**CONDITIONAL APPROVAL**  
**PLAN APPROVAL EXPIRES: 10/23/2010**

Northwoods Motel  
9854N State Hwy 27  
Town of Hayward  
Sawyer County  
NW1/4, SE1/4, S33, T41N, R9W

Description: Conventional system, 9 motel rooms, 1 br res, 1 fd  
Object Type: POWTS Component Manual Regulated Object ID No.: 1204378  
Maintenance required; Replacement system; 1,065 GPD Flow rate; System(s): Conventional POWTS Component Manual, SBD-10567-P (R.6/99); Commercial System

**GRAVITY CONVENTIONAL DESIGN**  
**Index and Title Sheet**

## Cross Section of a Three Cell Inground Component Using Leaching Chambers

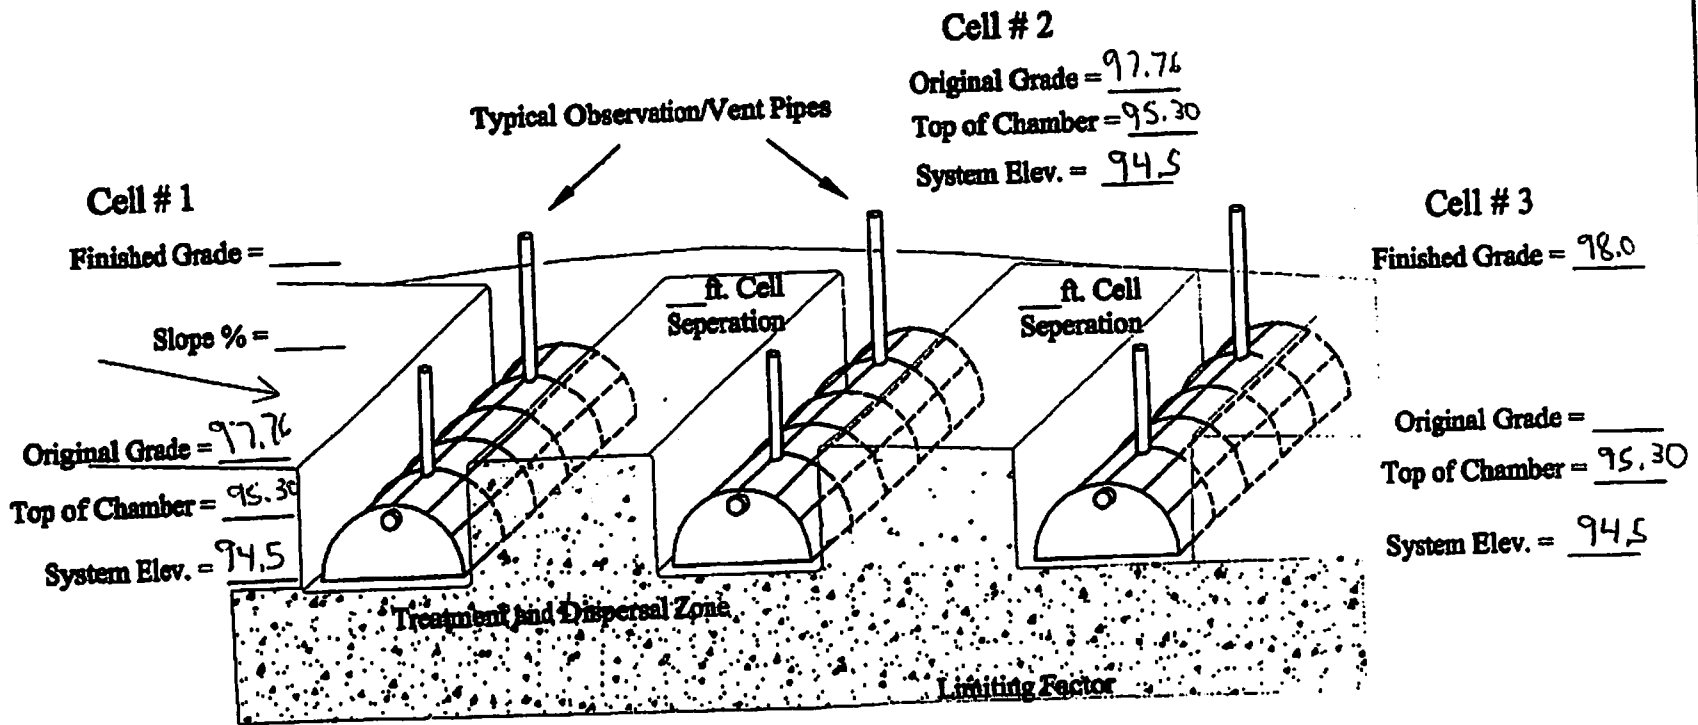
- The existing septic tank must be inspected for structural soundness, size and baffles and must be brought into conformance with the requirements of COMM 83, Wis. Adm. Code. If it does not conform a state approved tank must be installed.

- The gravelless system components must be installed in accordance with the manufacturer's printed instructions, the plan approval, and COMM 83 system sizing criteria. If there is a conflict between the manufacturer's instructions and the plan approval, the plan approval and code requirements will take precedence.
- The designer proposes to install an outlet filter to achieve the requirement of wastewater particle size. Access to the filter for cleaning must be provided per ss. Comm 84.25 (7) and (8), Wis. Adm. Code product approval conditions. Maintenance information must be given to the owner of the tank explaining that periodic cleaning of the filter is required. The outlet filter shall be installed per product approval stipulations.
